As-Built
Contractor: Pacific Pile & Marine
PE: Steve Mielke
Begin Date: 6/18/2013
End Date: 1/27/2014

WRANGELL FERRY TERMINAL IMPROVEMENTS
WRANGELL, ALASKA

PROJECT No.
SHAK-MGE-STP-0943(25)/69432

1/5 DETAIL X-CHAIN

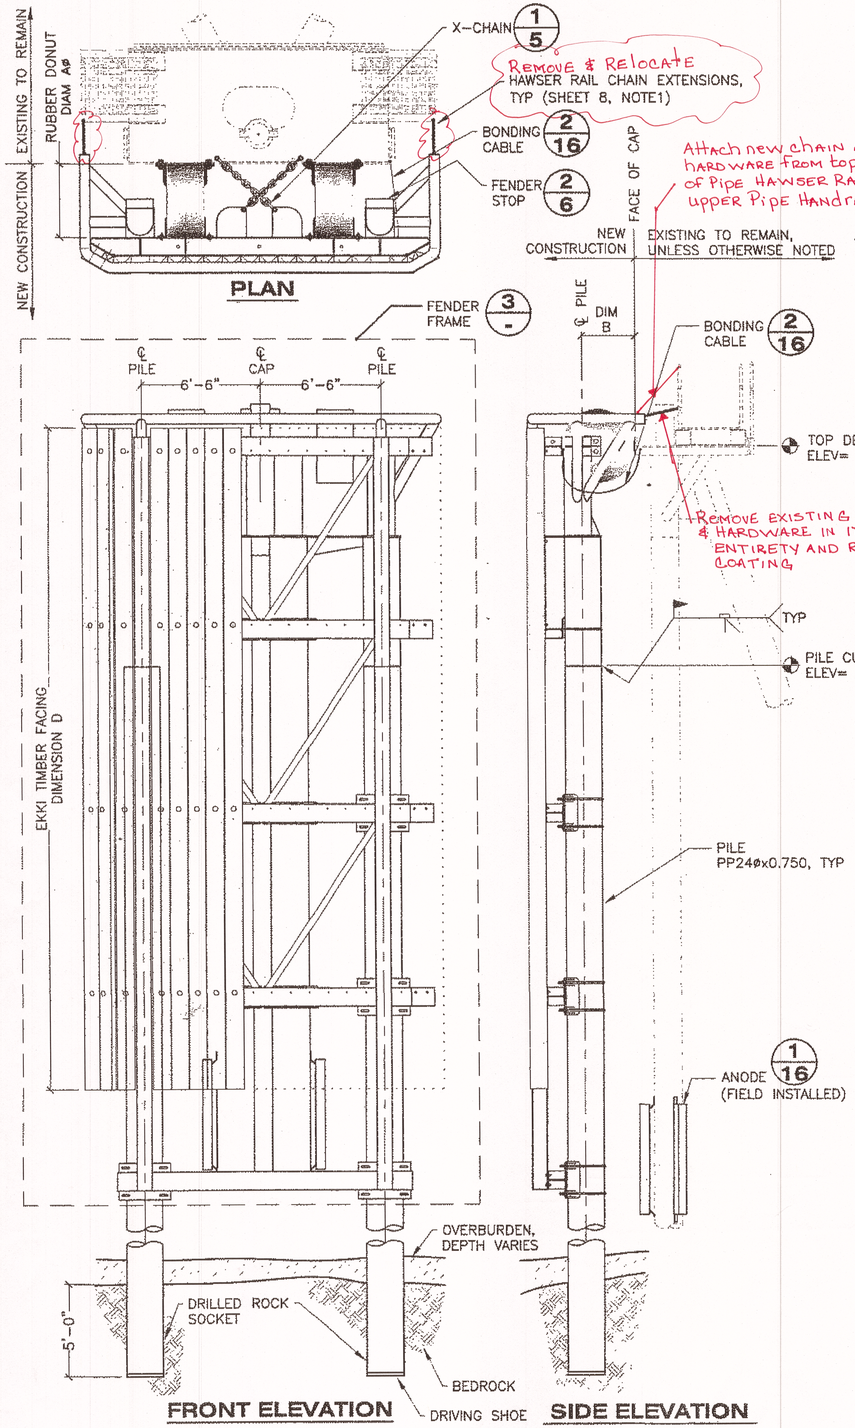
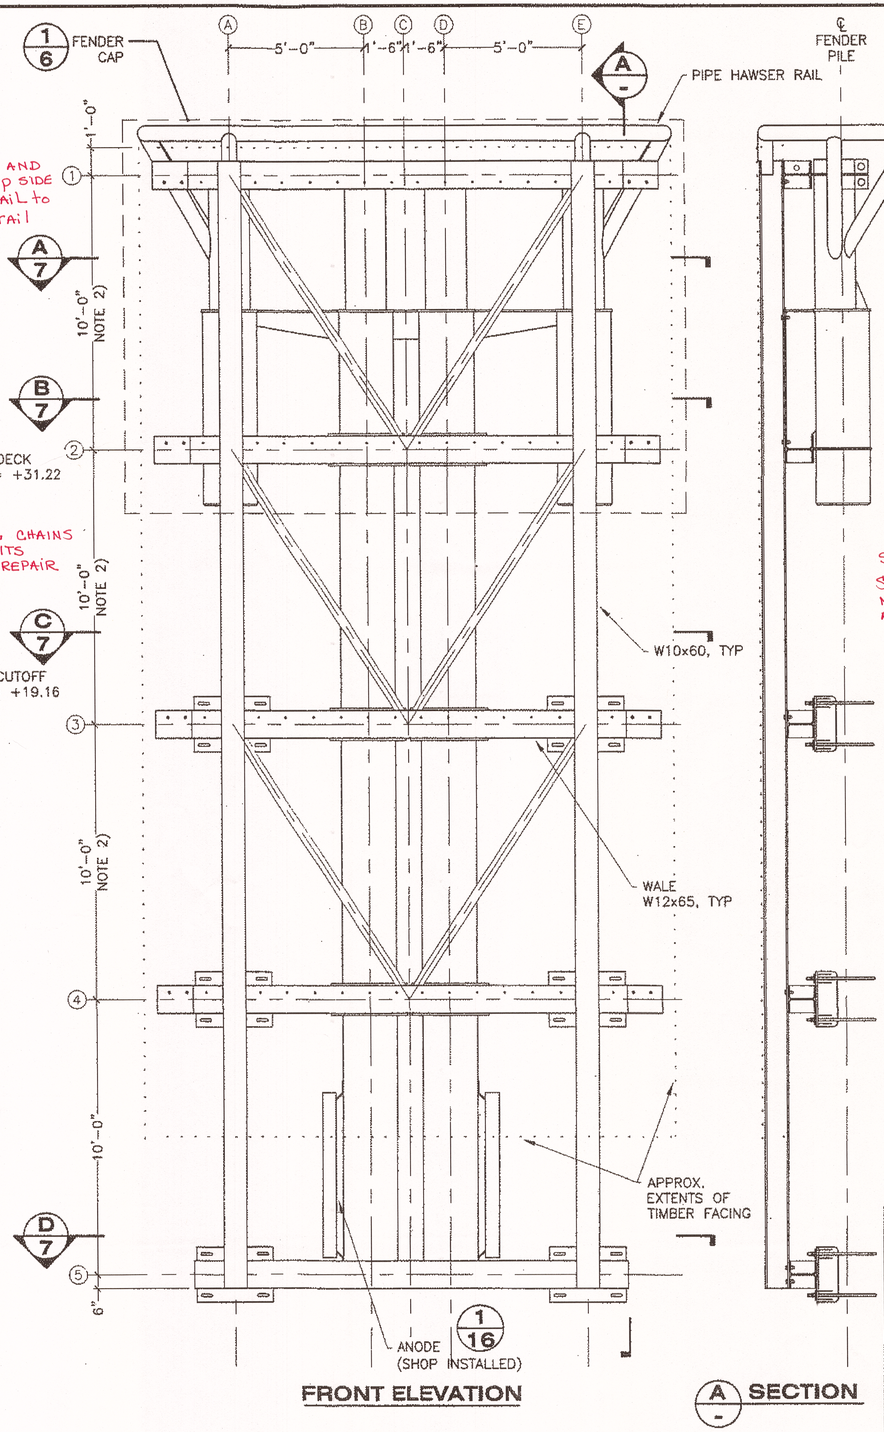
Match chain from top pipe of catwalk hand rail to top of Hawser Rail. No Shackle @ Hawser End

S1, S2, N1, N2, N3.
Slight slack in chain, but MAINTAIN NEGATIVE slope AWAY from pile hand rail

DOLPHIN S2 PLAN & ELEVATION

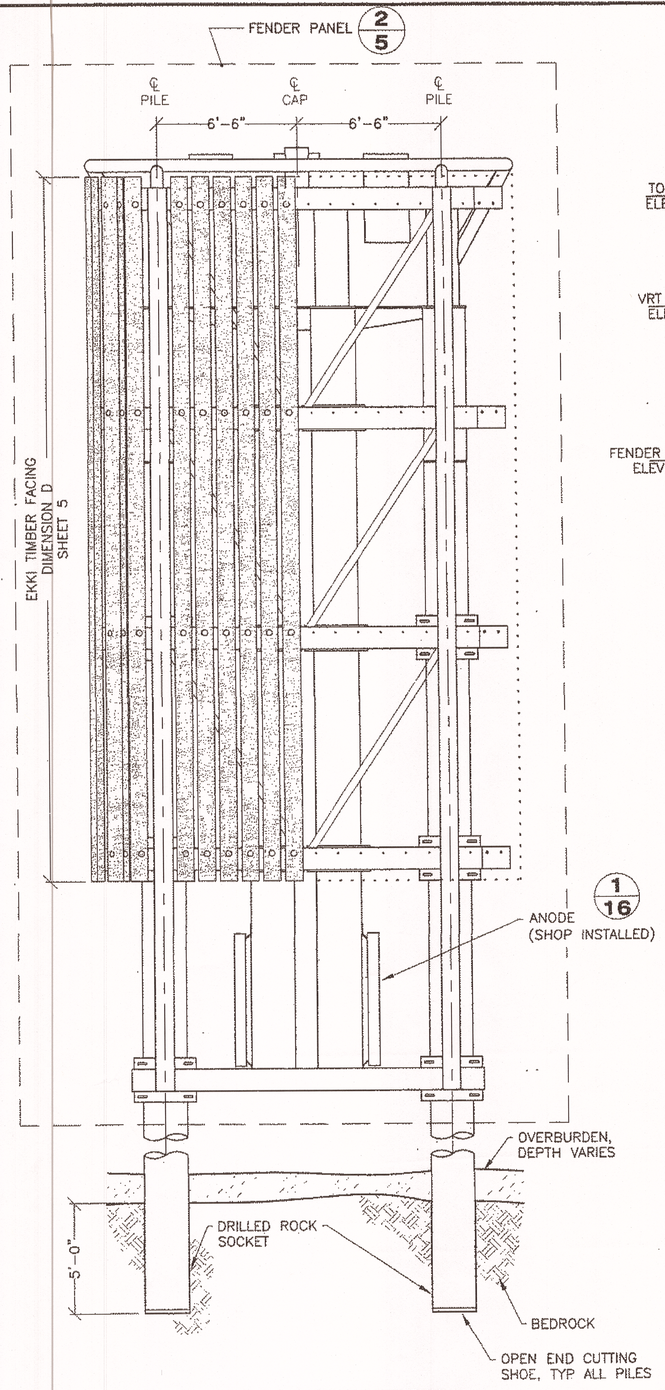
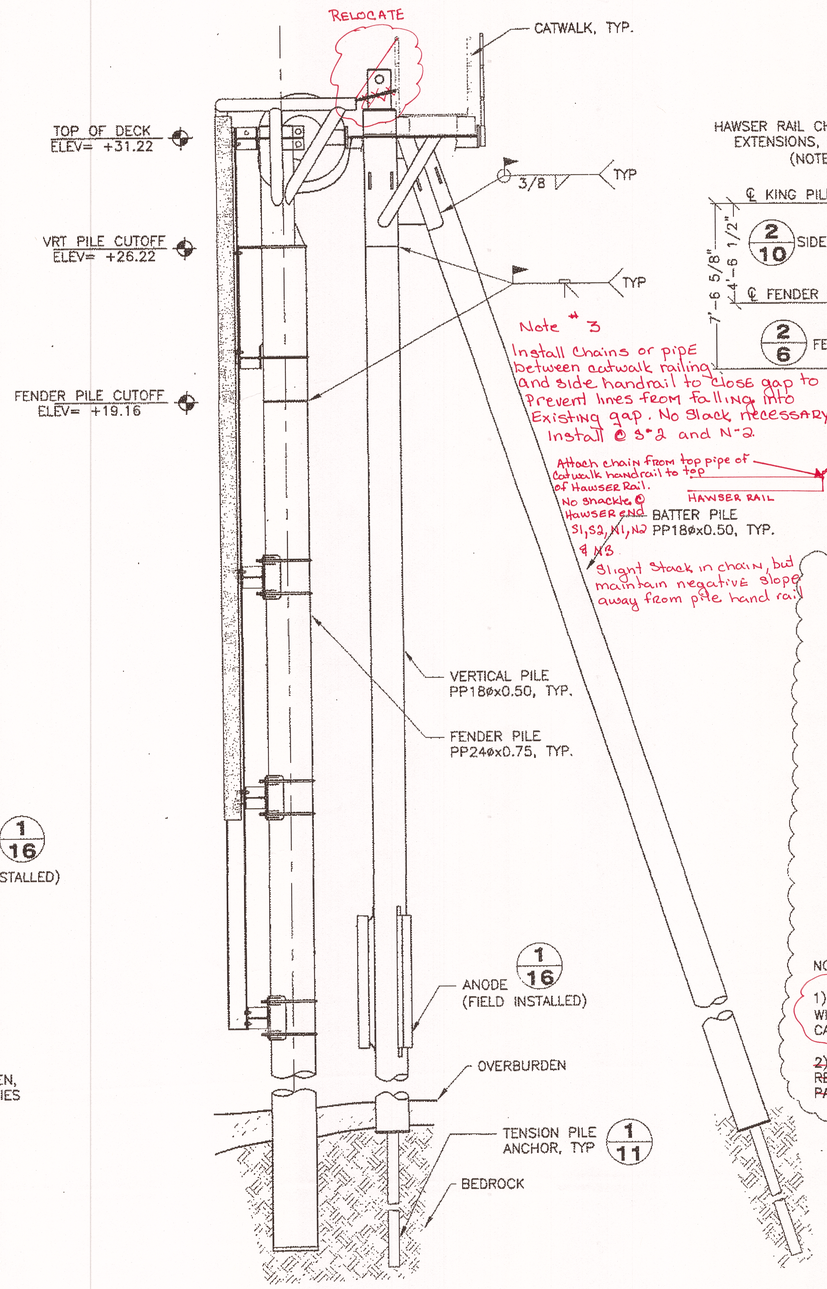
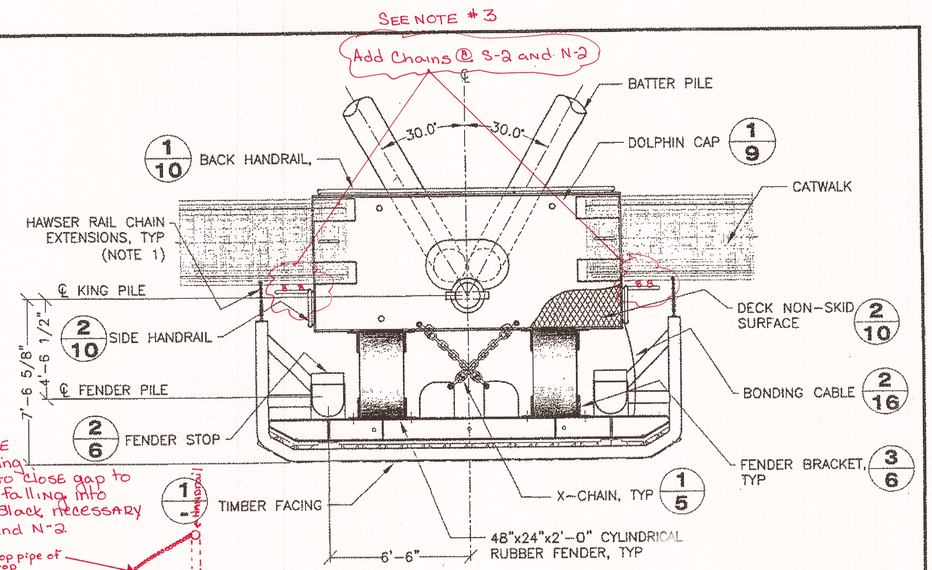
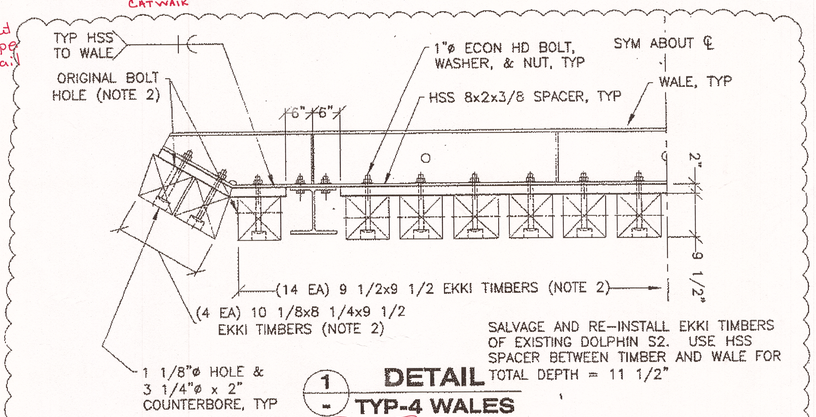
1) WELD CHAIN LINKS TO THE TOP HAWSER RAIL & upper CATWALK RAILING, CONNECT TO GALV. 3/16" GR.30 CHAIN WITH 3/16" SHACKLES, ~~EACH END~~; COVER WITH 3/4" VINYL TUBING, TYP. LEAVE ~~ENOUGH~~ Little SLACK FOR CATWALK MOVEMENT. & handrail end only

2) ~~BOLT SPACING OF TIMBERS ON EXISTING DOLPHIN S2 AND NEW FENDER PANEL DO NOT MATCH. RE-DRILL AND COUNTERBORE ALL BOLT HOLES TO MATCH NEW WALES. PLACE 14 TIMBERS ON FACE OF PANEL WITH ORIGINAL BOLT HOLES PARALLEL TO WALE, OTHERS TO BE PERPENDICULAR TO WALE.~~
